Work Order ID 156218

Item Name: Cap

DESIGN #	DRAWN BY CP	DART AEROSPACE LTD HAWKESBURY, ONTARIO, CANADA	
CHECKED #	APPROVED #	DRAWING NO. D3183	REV. C SHEET 1 OF 4
DATE 04.02.17		TITLE BRACKET ASSEMBLY	SCALE 1:1
A	03.01.24	NEW ISSUE	
B	03.06.17	REMOVE BEARING; 1.012 WS 0.882	
C	04.02.17	ADD -045/-9; 0.182 WAS 0.431	
CI	# 04.11.09	0.830 WAS 0.850

DRAWING NO. D3183	TITLE BRACKET ASSEMBLY	REV. C1	DART AEROSPACE LTD ENGINEERING ORDER		D.E.O. NO. D3183-C1-1	SHEET NO. SHEET 1 OF 1	SCALE NTS
DRAWN <i>q</i>	CHECKED <i>h</i>	MFG. APPR. <i>h</i>	APPROVED <i>MP</i>	DE APPR. <i>h</i>			
DATE 10.05.14	DATE 10.06.30	DATE 10.06.30	DATE 10/06/30	DATE 10/06/30

D3183-5 BEARING:
SPECIFICATION CONTROL DRAWING

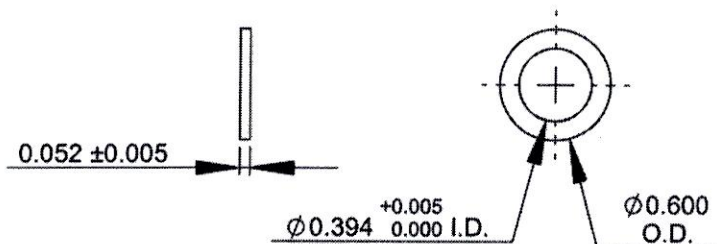
D3183-5 BEARING

ADD POSSIBLE SUPPLIER: KML P/N 6800-ZZ

BASIC LOAD RATING REQUIREMENT: Cr = 1720 N (386 lb) MIN [DYNAMIC]
Cor = 840 N (188 lb) MIN [STATIC]

REF PAR 10-012
